CACTUS ROAD
STORM DRAIN STRUCTURES

FLOOD CONTROL DISTRICT OF MARICOPA COUNTY

DATE: **APR. 3, 1996**
TO: **MAL** MAL
FROM: **KVH** KVH.
SUB: **CACTUS ROAD STORM DRAIN**

The following are the review comments for the shop drawings of Cactus road storm drain from 83rd Ave. To 75th Ave.

Revised Detail

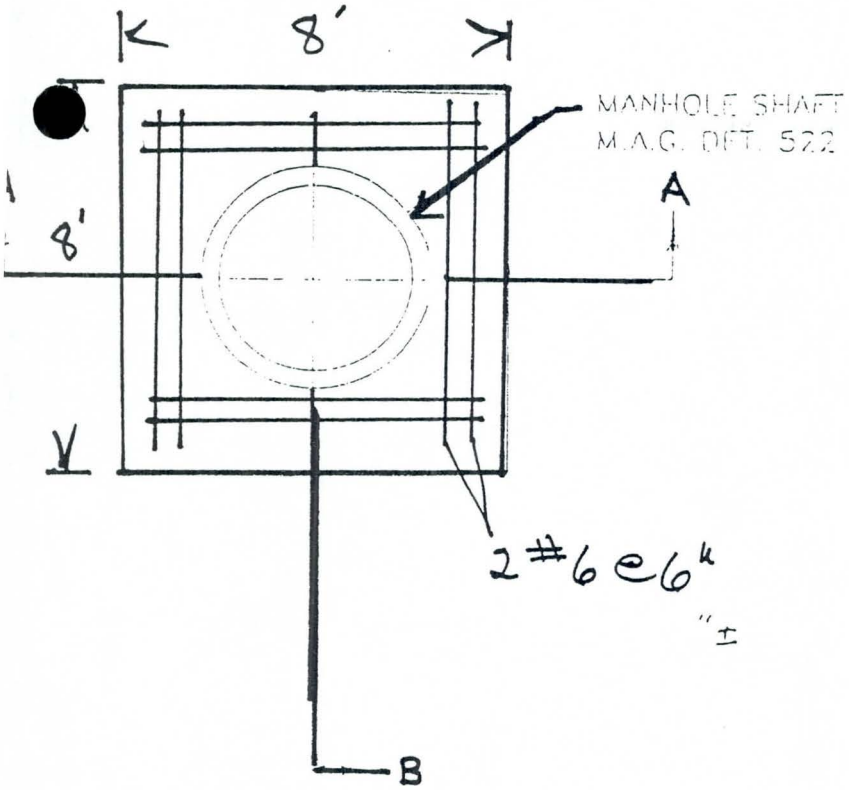
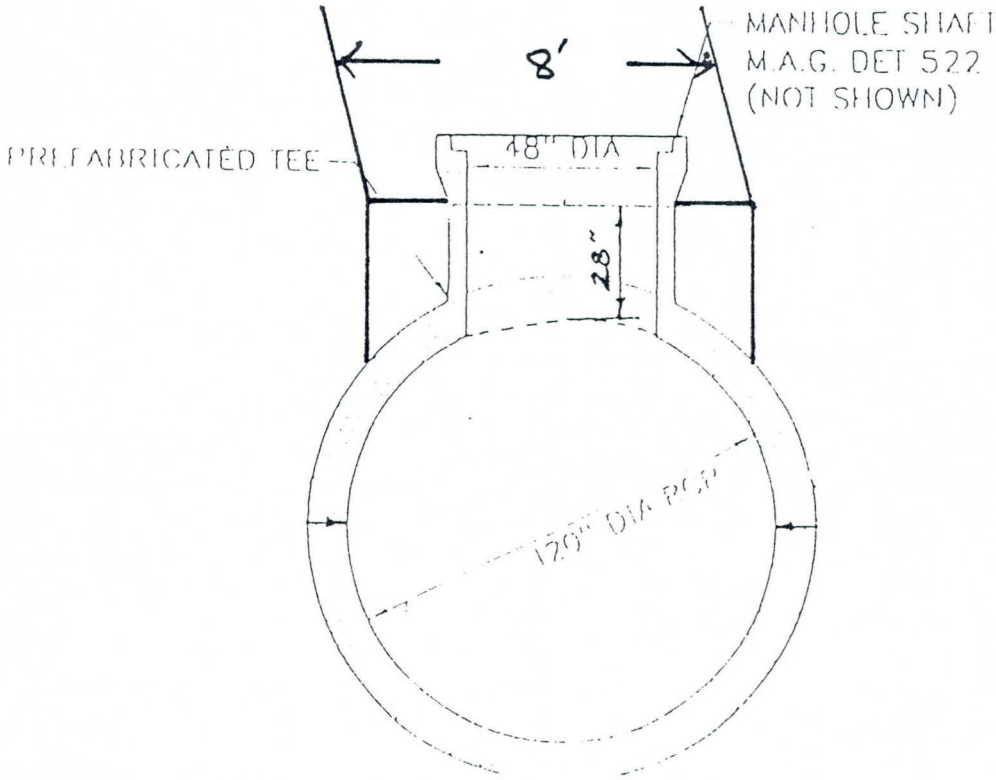
The VE proposal from Sundt for the Manhole Base is not acceptable. It does not provide an equivalent structure to the one that was specified. It further does not appear to provide adequate structural support for the 120" pipe to resist the effect of the manhole.

I am particularly concerned that the manhole will transfer its load through the proposed concrete cap directly onto the 120" pipe at a section that is weakened by a 4' diameter hole, and there is no additional support proposed around the pipe. The MAG detail handles this by encasing the pipe in concrete to provide support just as do the ADOT standard details and Phoenix standard details. The VE detail places concrete around the perimeter of the manhole on top of the pipe. My best guess is that the intent is to distribute the loading from the manhole to the top of the pipe as a footing. I am concerned that if placed in that fashion, the concrete cap will merely act as additional dead load on the crown of the pipe above the springline, while providing no support to the 120" pipe to allow it to resist the applied direct loading caused by the manhole at the weakened section.

In Brad Sando's written statement on behalf of Ameron, he says the VE proposal very nearly matches a concrete arch detail from the Concrete Pipe Design Manual. This statement is incorrect. The detail from the manual shows encasement over the crown of the pipe to the springline and special bedding below, and there is not a 4' hole in the pipe in the detail. If the detail were followed as shown in the manual, it would in our case translate to a concrete arch 15 feet wide by 8-1/2 feet deep measured along the outside edge, along with special bedding. The VE proposal calls for a concrete cap that is 8' wide by 28" deep measured at the crown of the pipe, all placed well above the springline. Further, the concrete arch detail in the manual appears to be for the case of a load applied above the top of the concrete arch. This is not our situation. The manhole bears on and transfers loads directly to the top of the 120" pipe.

3. Utilization of the MAG Standard detail will avoid any issues that might arise with this modification.
